Access Compliance Report

Public Rights-of-Way

Intersection ID: 29677	Main Street: CAMERON_CREEK_DR	Cross Street: HUNTINGTON_RIDGE_CT	Location: SW
ADA ID: 845C204A2384	Ramp Type: PerpDiag	Initial Pass/Fail: Fail	Overall Compliance: No
		Severity Score: 12.5

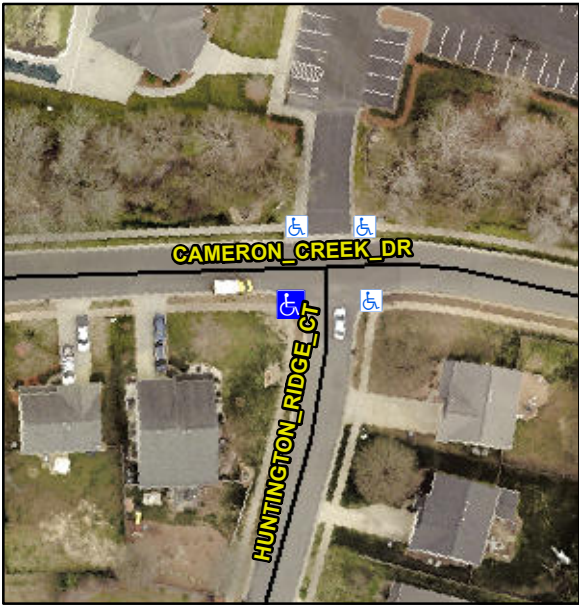
Codes/Mitigation Info/Possible Solution			Field Measurements/Component Compliance					
	Possible Solutions:		Compliance	Description	Data	Compliance	Description	Data
	Remove & Replace Curb Ramp With Two New Directional Ramps or Equivalent.		N/A	Ramp Length (in)	45.0	No	Ramp Slope (%)	8.5
			Yes	Ramp Width (in)	48.0	Yes	Ramp XSlope (%)	0.6
			N/A	Flare Type LT	N/A	N/A	Flare Type RT	N/A
			N/A	Flare Slope LT (%)	N/A	N/A	Flare Slope RT (%)	N/A
			N/A	Flare Traversable LT?	N/A	N/A	Flare Traversable RT?	N/A
			N/A	Landing Length (in)	N/A	N/A	DWS Provided?	N/A
			N/A	Landing Width (in)	N/A	N/A	DWS Contrast?	N/A
			N/A	Landing Slope (%)	N/A	N/A	DWS Length (in)	N/A
			N/A	Landing X Slope (%)	N/A	N/A	DWS Full Width?	N/A
Surveyor Notes:	N/A		N/A	Landing Curb? (Y/N)	N/A	N/A	DWS Offset (in)	N/A
			N/A	Shared Landing?	N/A			
	PROW/ADA:		N/A	Gutter Ponding?	N/A	N/A	Gutter Slope (%)	N/A
	Not Found, R304.2.2		N/A	Gutter Lip Ht (in)	N/A	N/A	Gutter X Slope (%)	N/A

N/A	Painted X Walk1?	No	N/A	Painted X Walk2?	No
				X Walk 1 Direction	To E		X Walk 2 Direction	To N
			N/A	X Walk 1 Width (in)	N/A	N/A	X Walk 2 Width (in)	N/A
				X Walk 1 Slope (%)	0.5		X Walk 2 Slope (%)	4.2
				X Walk 1 X Slope (%)	0.1		X Walk 2 X Slope (%)	1.1
			N/A	Ramp inside XWalk1?	N/A	N/A	Ramp inside XWalk2?	N/A
			Road Slope (%)	1.9	N/A	Clear Space?	N/A	
			Road X Slope (%)	0.9	N/A	Clear Space to XWalk (in)	N/A	
		N/A	Any Obstructions?	N/A	N/A	Storm Grate/Utility Hazard?	N/A	
			Obstruction Type			Storm Grate/Utility Type		
				N/A			N/A	
					Yes	Surface Condition? (G/P)	Good	
Total Cost:		\$ 3200.00
